PROJECT: OUSD MIRA MONTE FIELD RENOVATION
RE: Bid RFI Response
DATE: May 20th, 2021

RFI Emails 1 & 2 - Sam Bennett with Summer Construction

RFI 05-19-21 from Chris Ngo with Marina Landscape, Inc.

STANDARD DRAWING	PROJECT NO.	
ARTWELD GABIONS		SHEET 1
DETAILS AND NOTES		OF 2

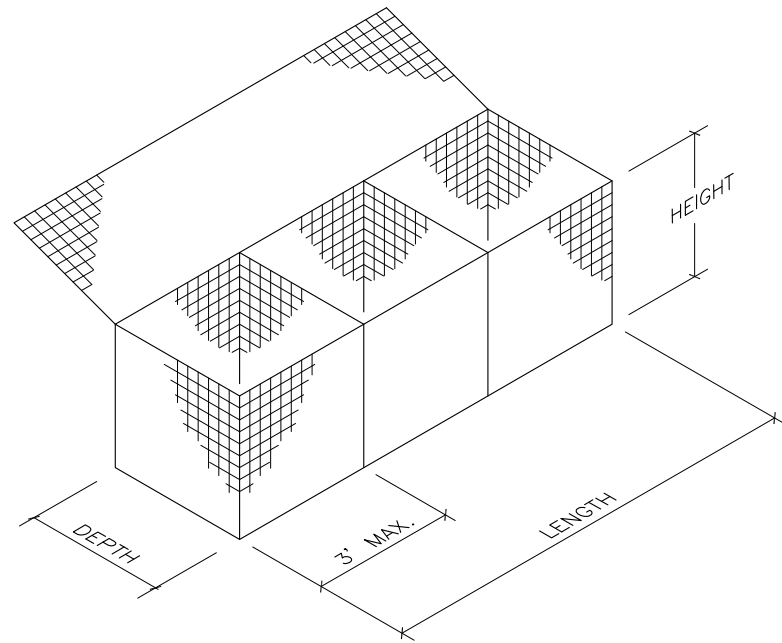
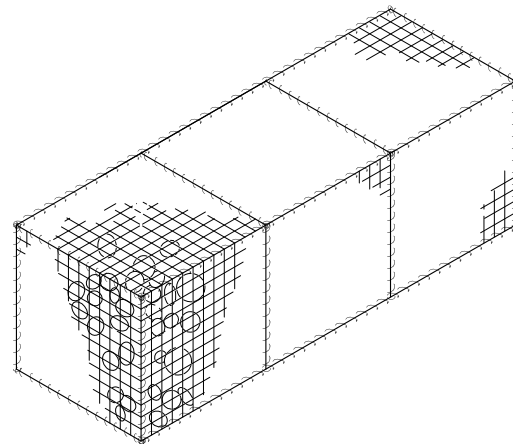
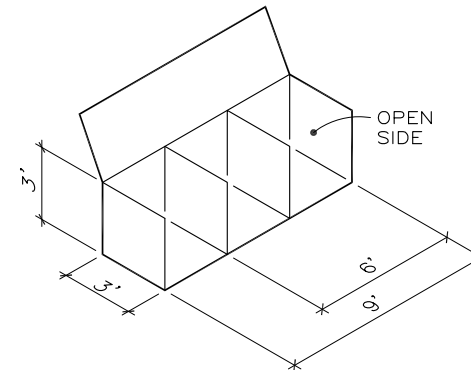
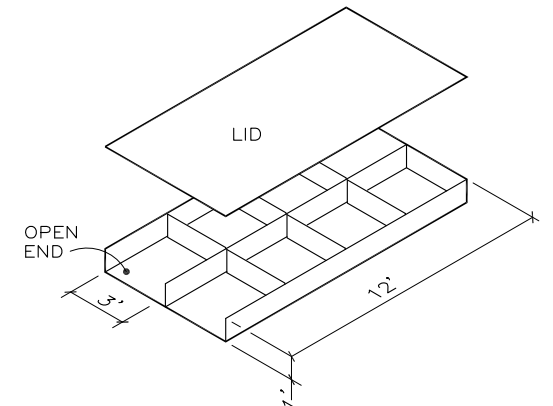
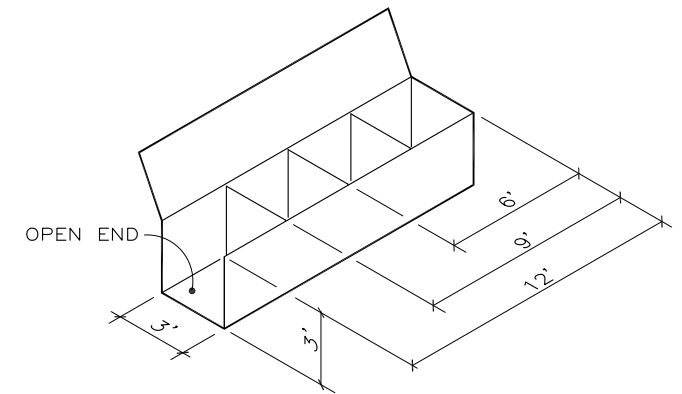
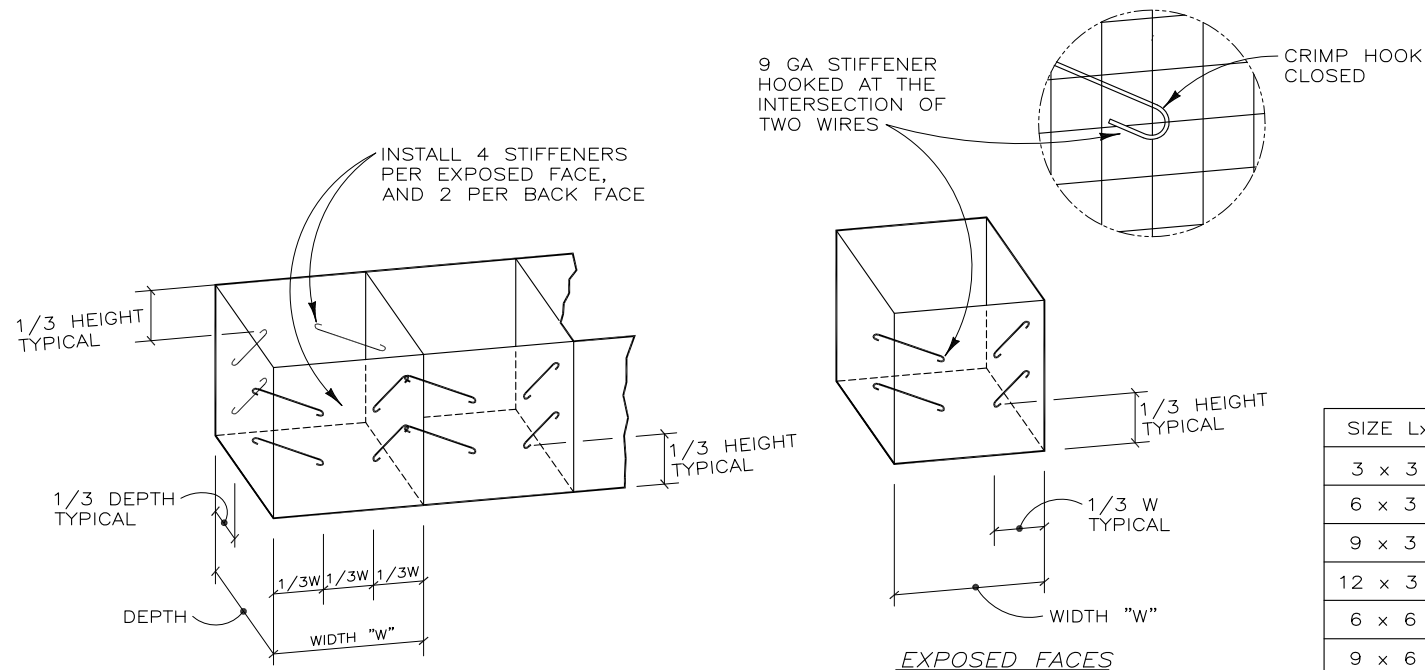
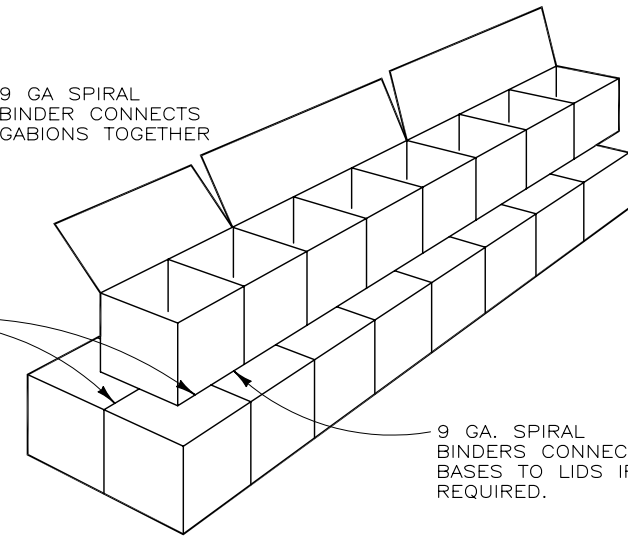
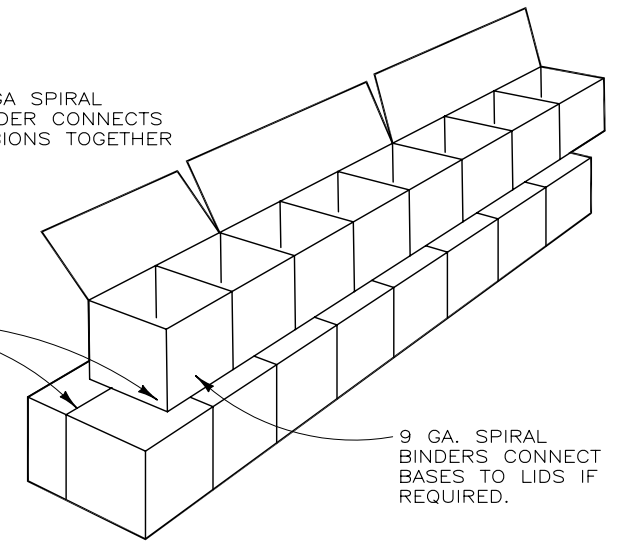
- a. See attached MFR details and specifications for gabion walls.
4. *Please indicate who the manufacturer is for the gabion retaining walls.*
 - a. Gabion wall Manufacturer: HILFIKER RETAINING WALLS, 1902 Hilfiker Lane, Eureka, CA 95503-5711. Phone: 707-443-5093. Email: info@hilfiker.com. Product: ArtWeld Gabion, Galvanized, 9 Gauge Wire, 3"x3"

AQUA-FLO SUPPLY		
MIRA MONTE SCH		
DESIGNED BY: FREEMAN FACILITIES		
SCALE: 1"=40'	DATE: 2-18-85	1141

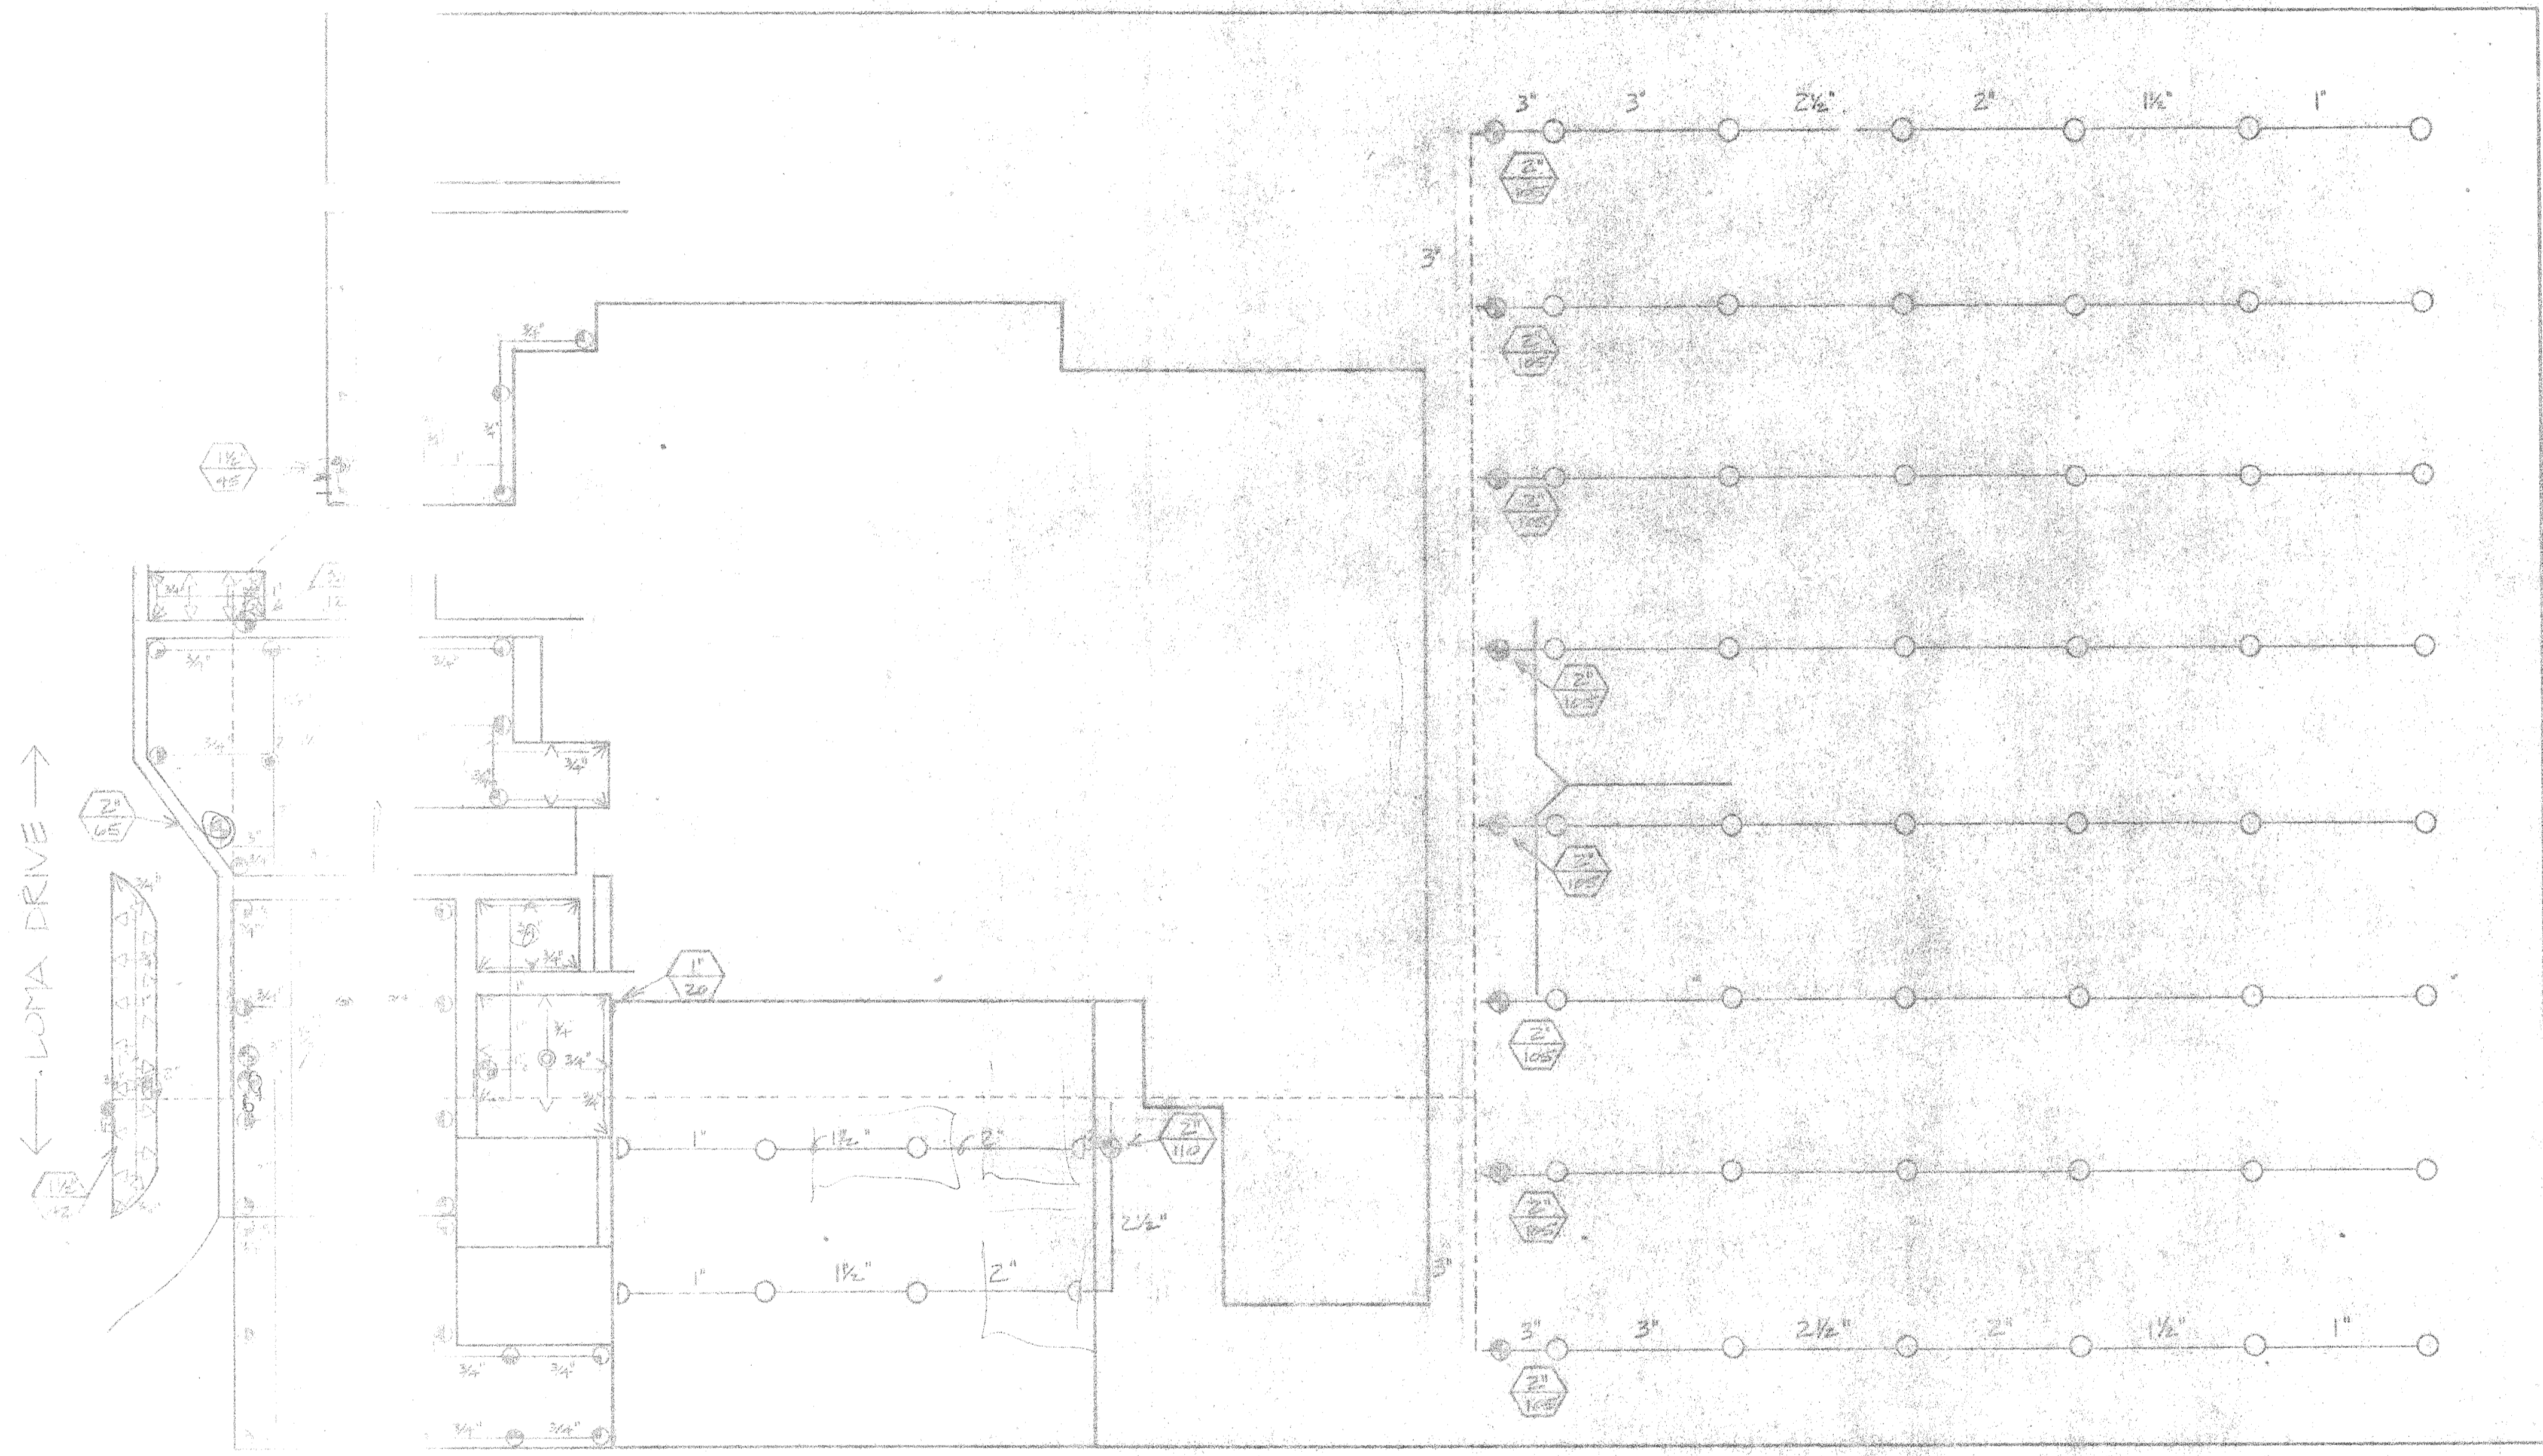
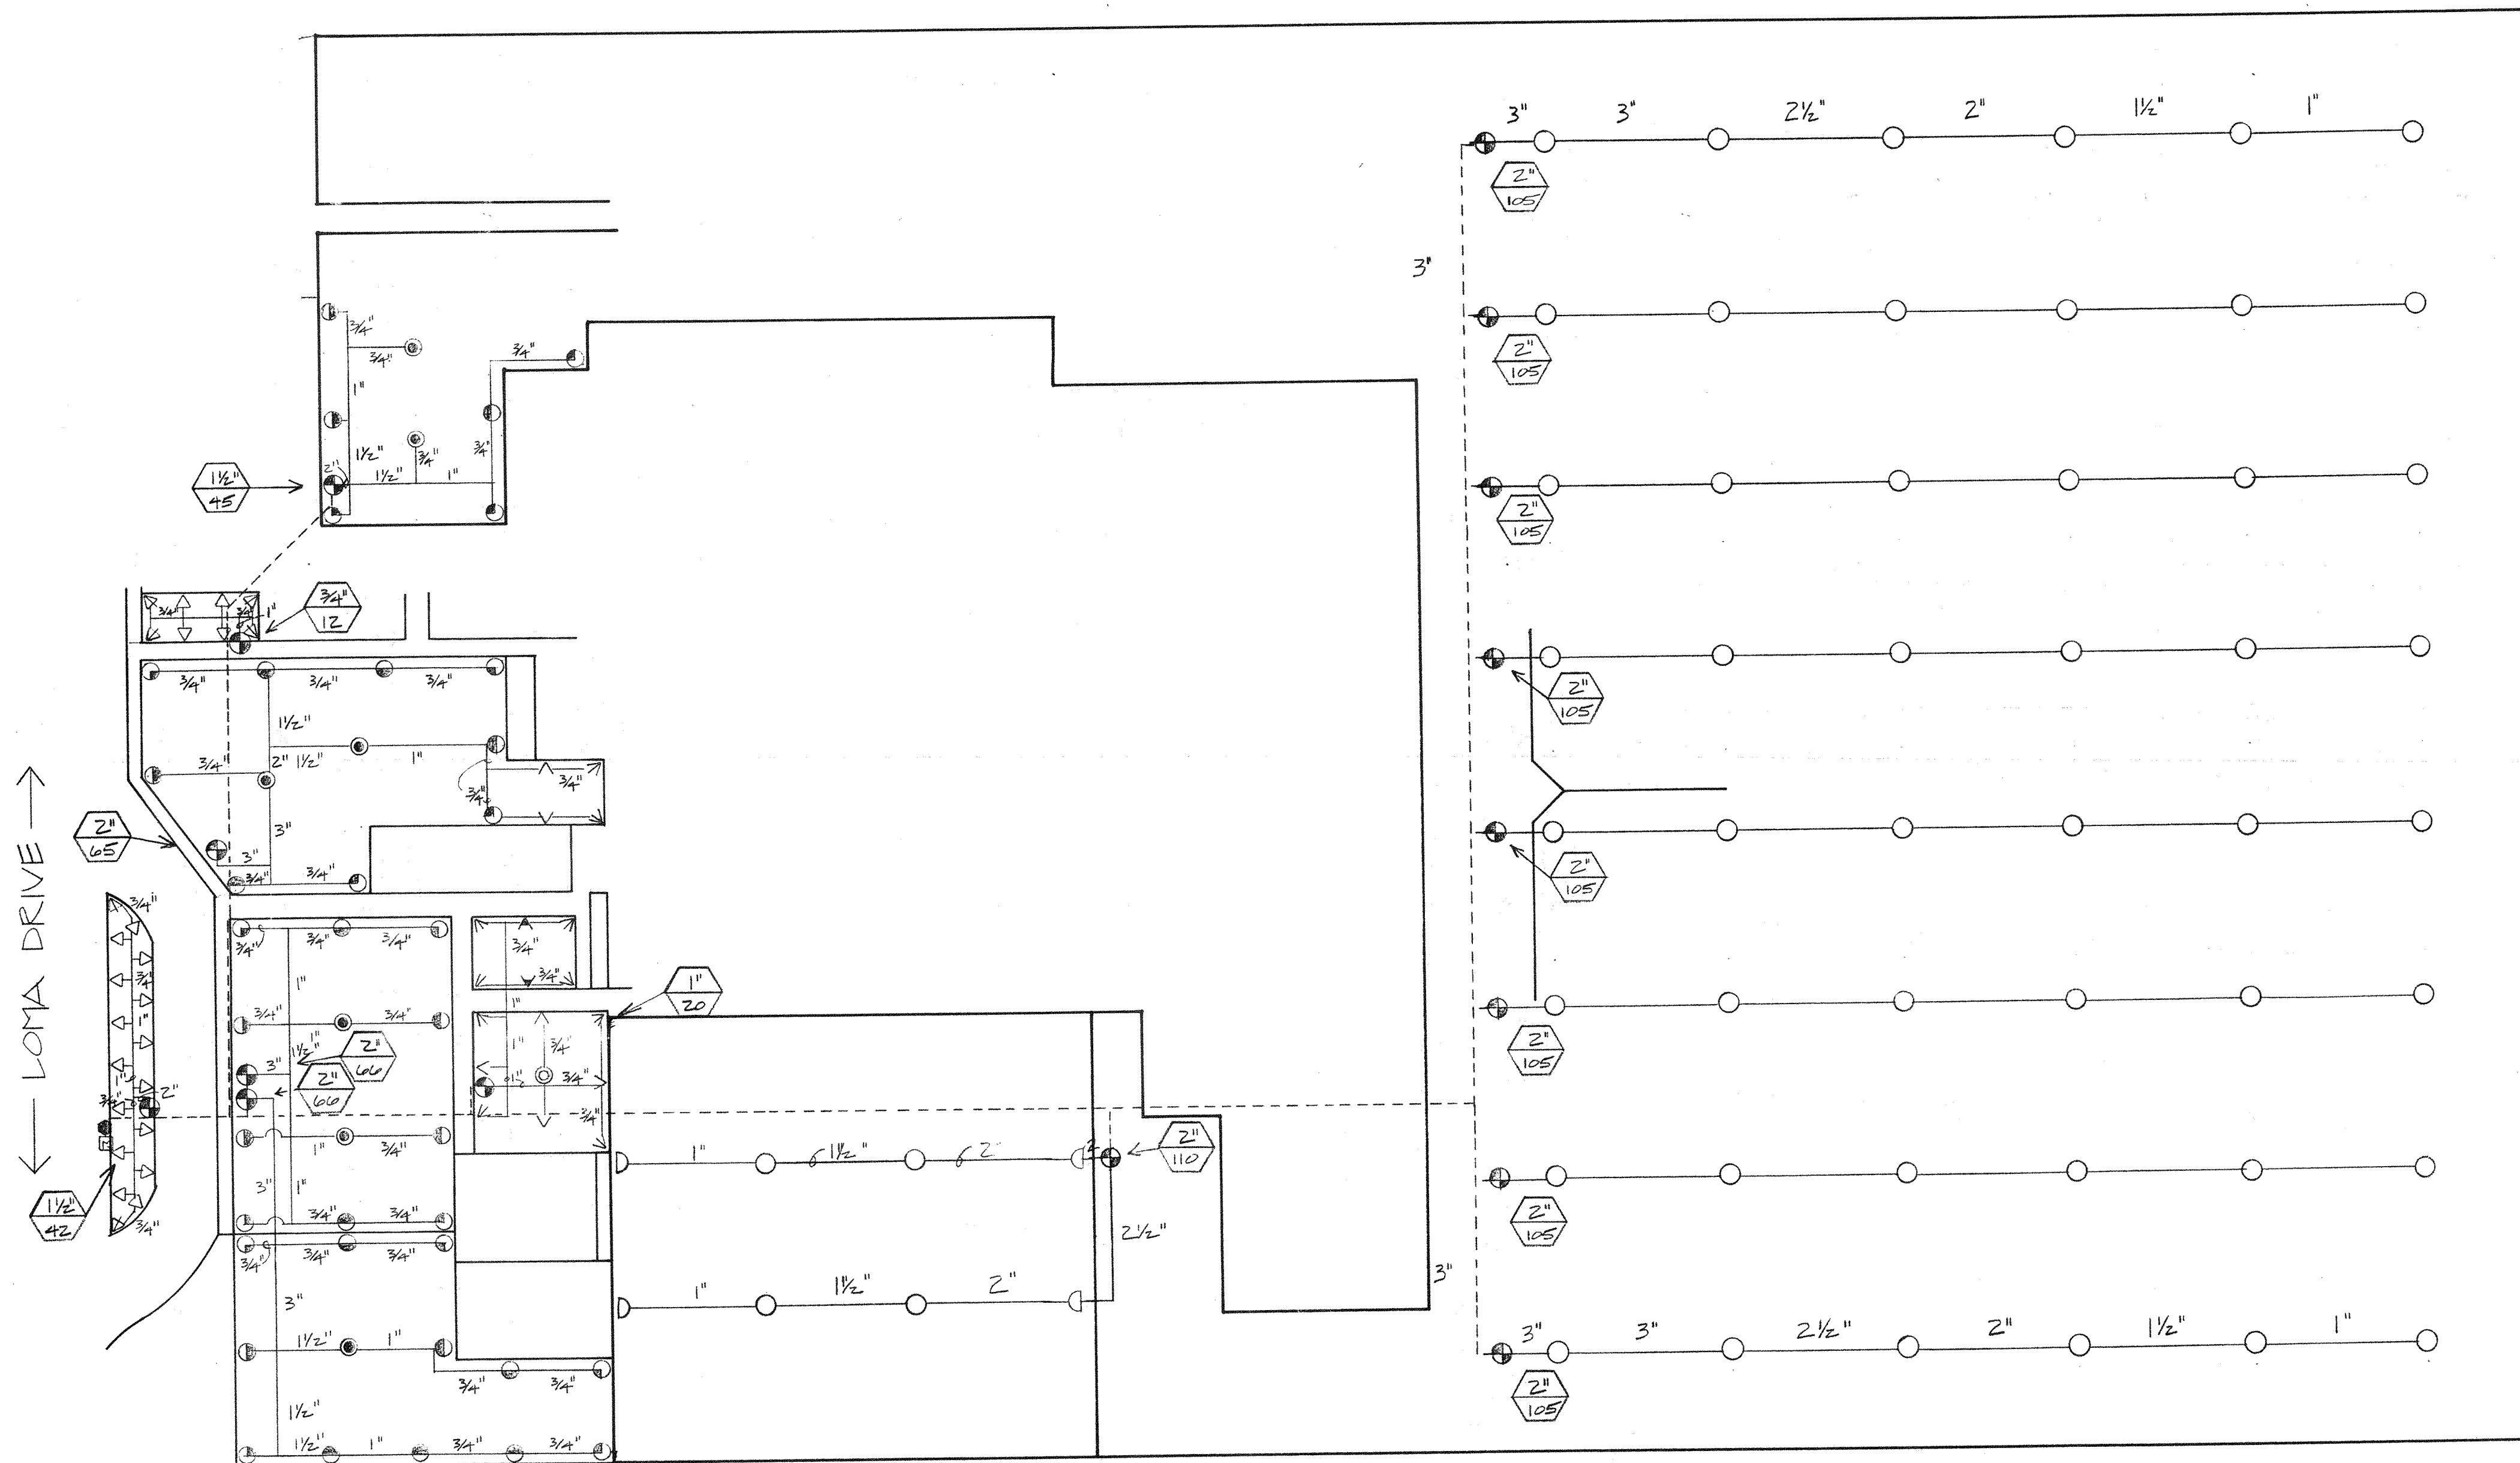
1. *Please provide as built irrigation plans.*
 - a. Please see attached As-Built Irrigation Plans
2. *Please provide the thicknesses and material type of existing paving that is to be removed. In addition, any known reinforcements.*
